CS Memorandum No. 1284

Subject: Configuration Management Board Meeting No. 99

CMB Meeting Minutes #99

SUBJECT: Configuration Management Board Meeting # 99– Rev. No. 0

Drawing Nos Figure 1 (BP-313, BP-316), Figures 2 and 3

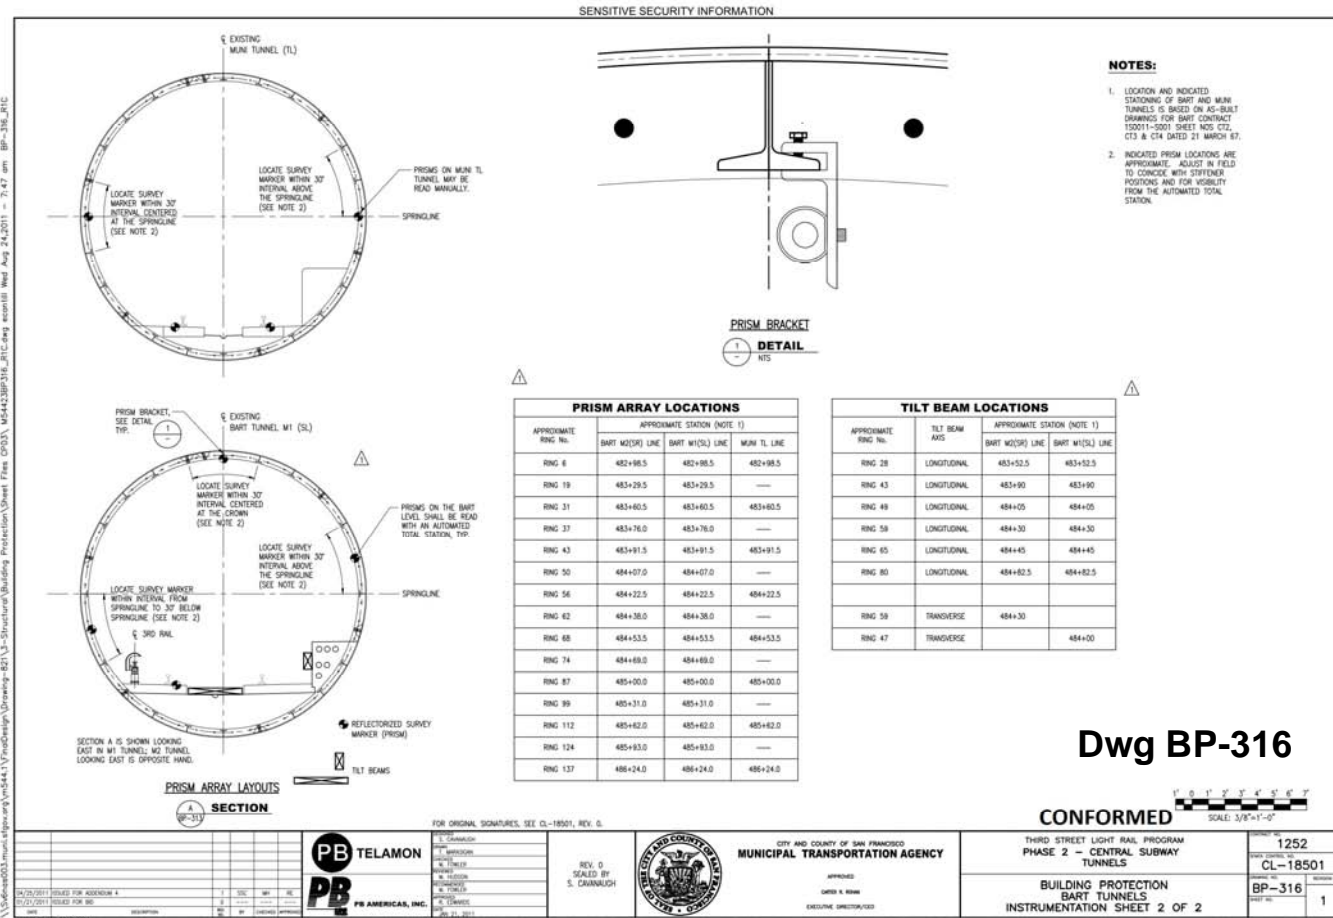
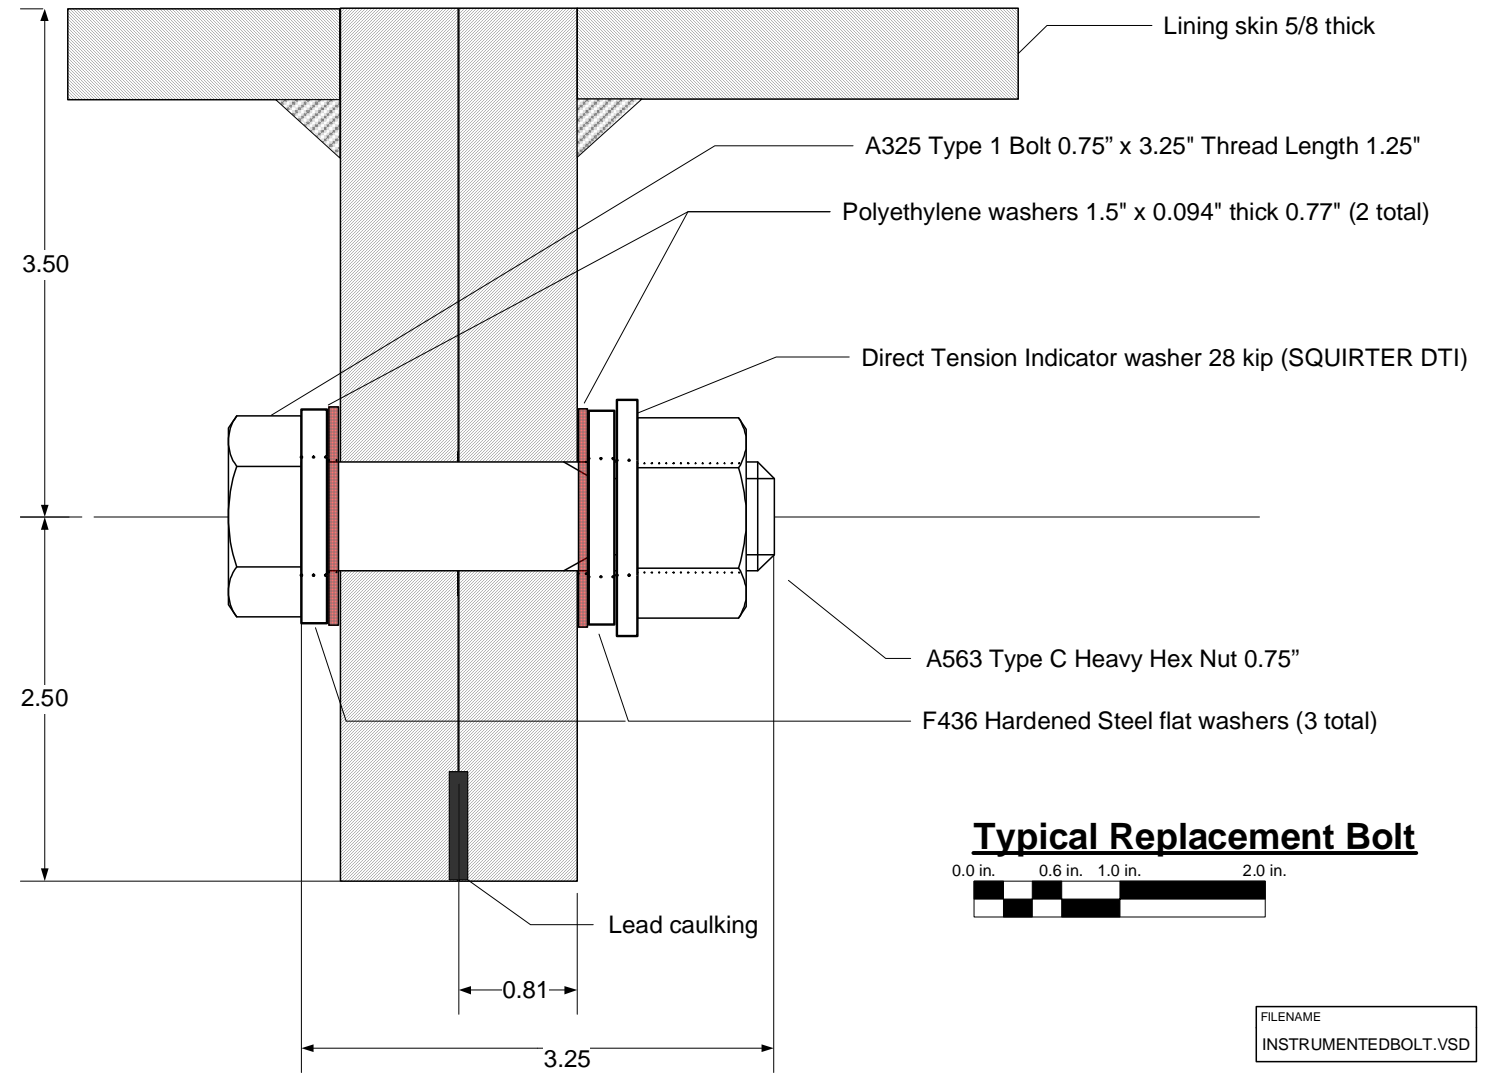
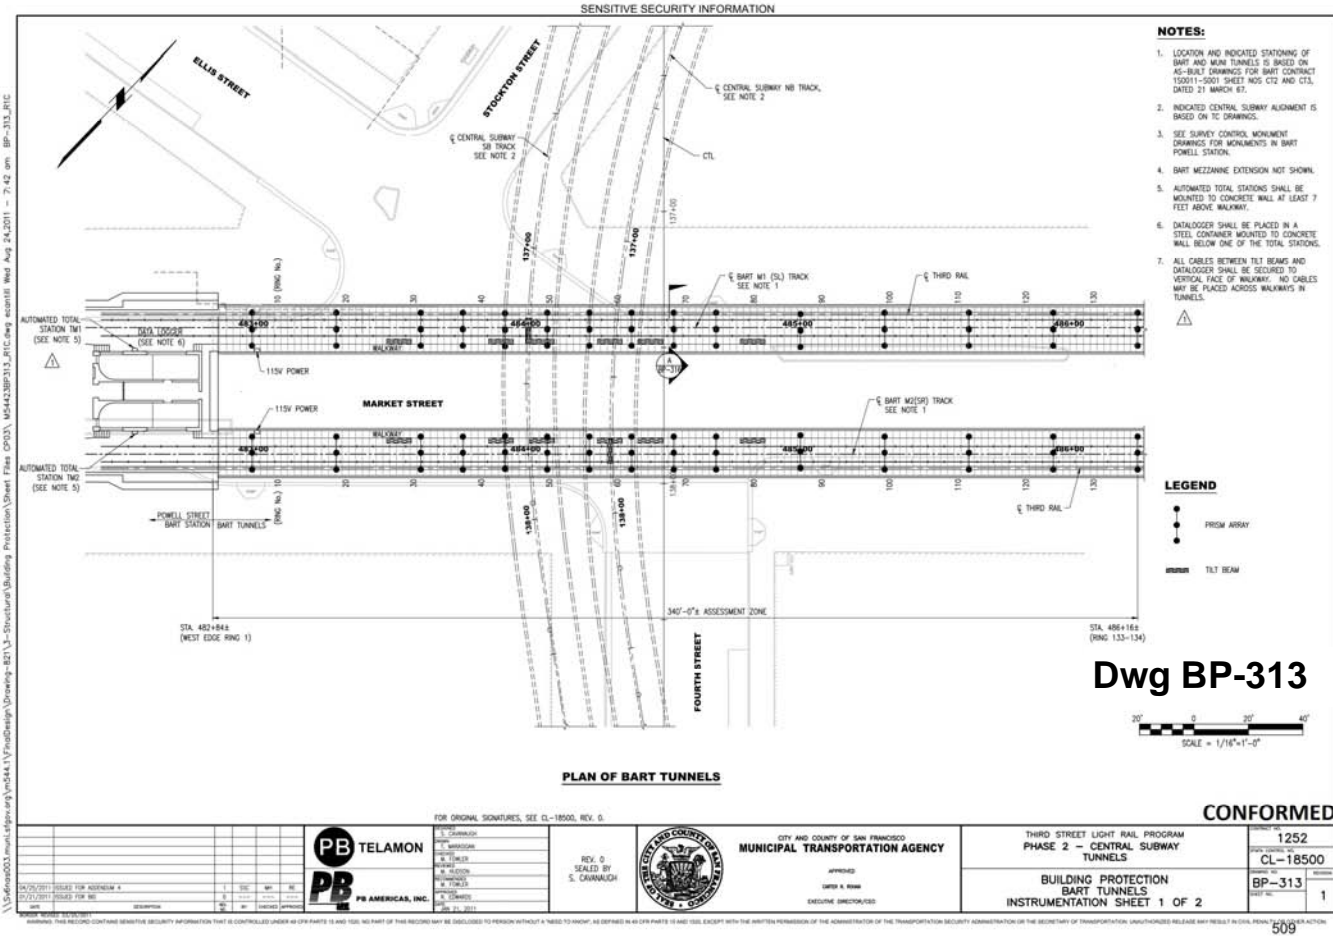
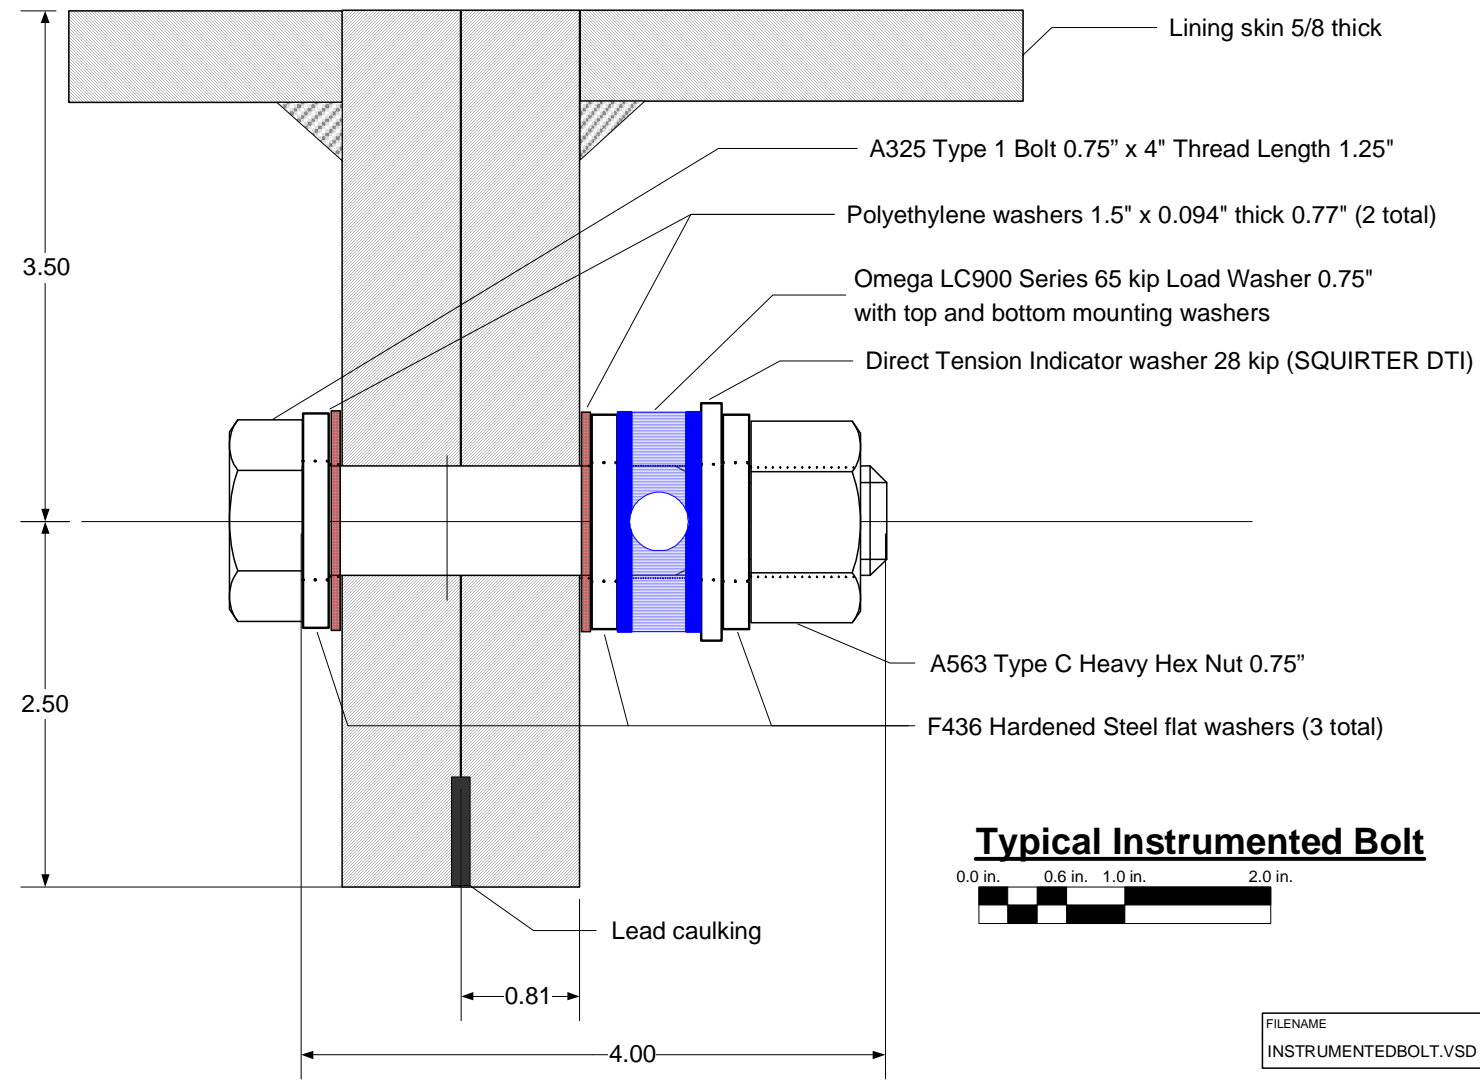
1. Implement additional instrumentation of BART tunnel lining:
 - A. Existing bolt preload force – Determine the actual load in 12 bolts identified in Figure 2 in each tunnel (M1 and M2) for a total of 24 bolts. The bolts removed for testing shall be replaced with the longer bolt and load washer configuration shown in Figure 3.

- B. Bolt force sensor – Install 12 bolt force sensors at bolts identified in Figure 2 in each tunnel (M1 and M2) for a total of 24 bolts. Bolt force sensors shall be added using new A325 bolts, nuts, flat washers. (See Figures 3 and 4 for layout of instrumented bolt and sensor data.) Bolt force sensors shall remain and not be later removed. Wiring from sensors to datalogger shall be affixed securely to tunnel and removed at completion of tunneling for Contract No. 1252 to the limits requested by BART. Monitor the forces in bolts per contract requirements.

- C. Rail movement under dynamic train loading – Install dynamic strain gauges (2 per rail, 8 per tunnel) at locations shown in Figure 2 in each tunnel (M1 and M2). Trigger for polling strain gauges on rapid cycle shall be automatic and based on detection of passing train. Monitoring shall occur in each of the BART tunnels at one location above each of the two CS tunnels (4 locations total) with monitoring only over the Central Subway tunnel being bored (one datalogger used for two applications).

Replace w/ 12-inch head (82)

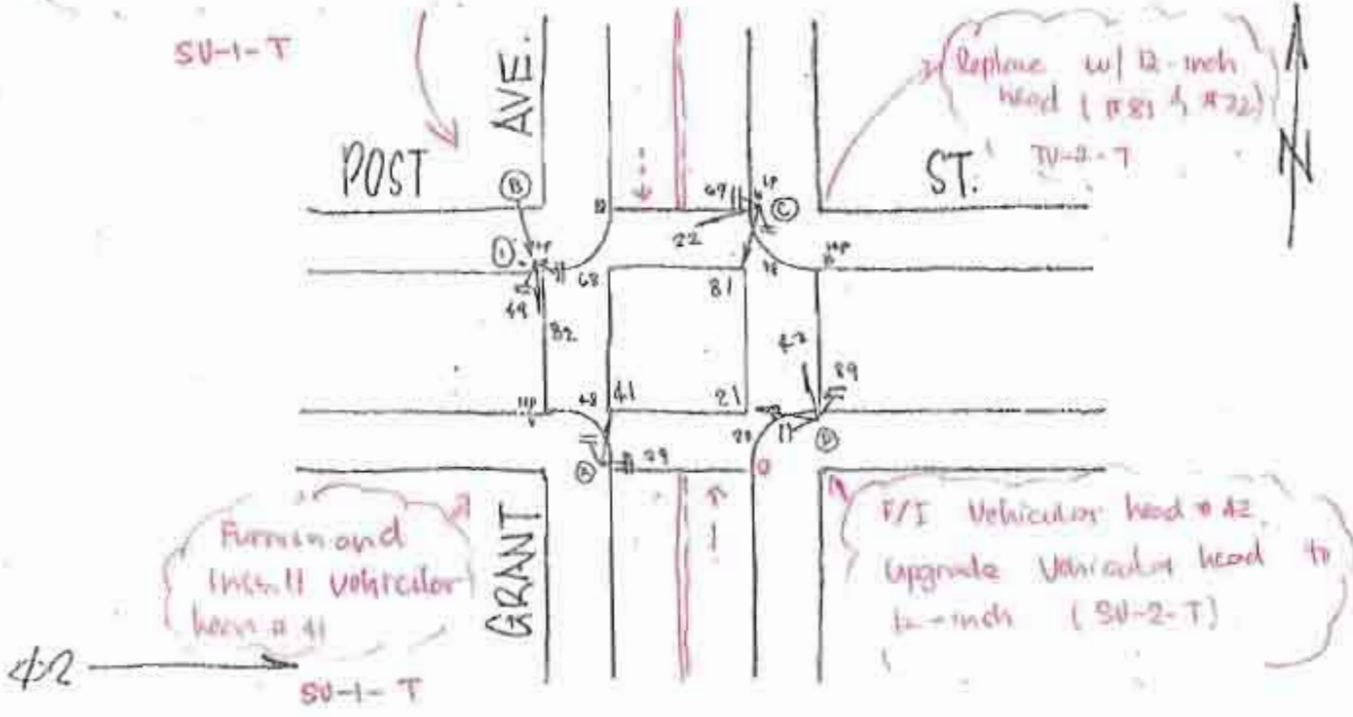
REPLACE EXISTING 8" INCH VEHICULAR TRAFFIC SIGNAL HEADS ~~WITH~~ TO 12" INCH.

COMMENTS : ^{EXISTING} # 82 — 4 SECTION 4RYG ← (8"RYG, 12"GR) } EXISTING
~~# 62 —~~
 # 41 — 4 SECTION 4RYG ← (8"RYG, 12"GR)

O'FARRELL STREET AND GEARY STREET
 PAVEMENT RENOVATION AND
 SEWER REPLACEMENT
 TRAFFIC SIGNAL PLAN
 GEARY ST AND GRANT AVE INTERSECTION

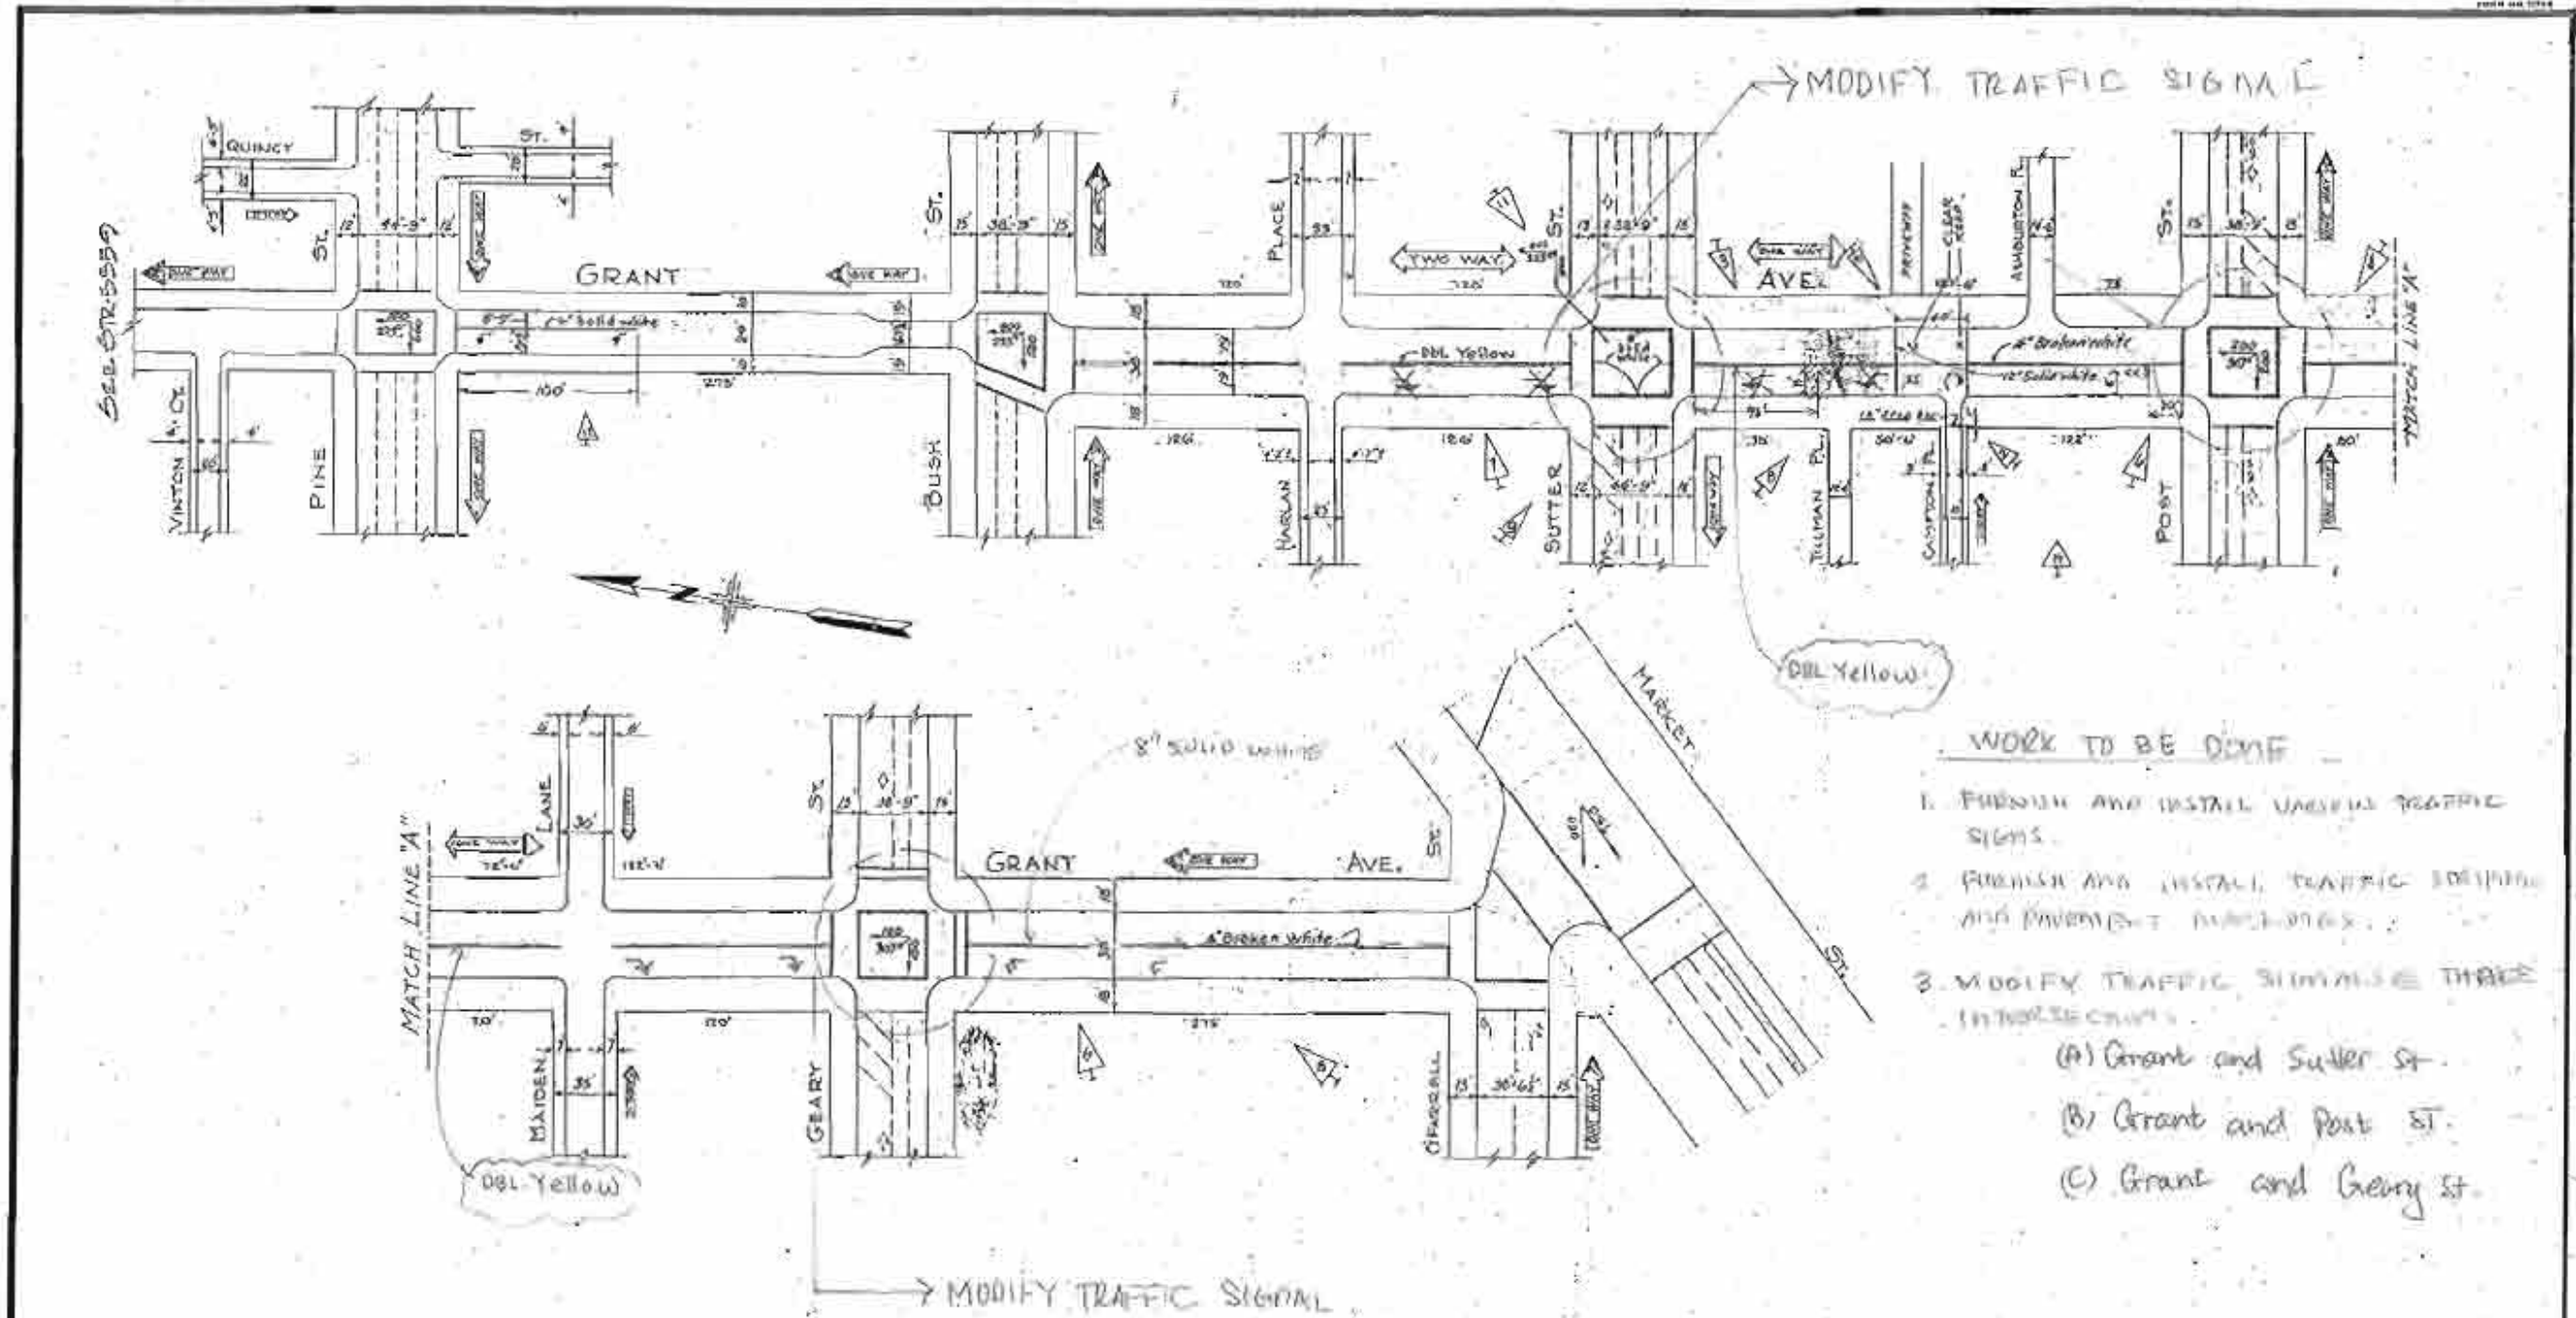
“Contractor shall convert Grant Avenue between Post Street and Geary Street from ONE-WAY to TWO-WAY Street and modify the traffic signal at Grant Avenue and Geary Street intersection. The Contractor shall submit a temporary traffic signal plan layout for approval prior to traffic signal modification.”
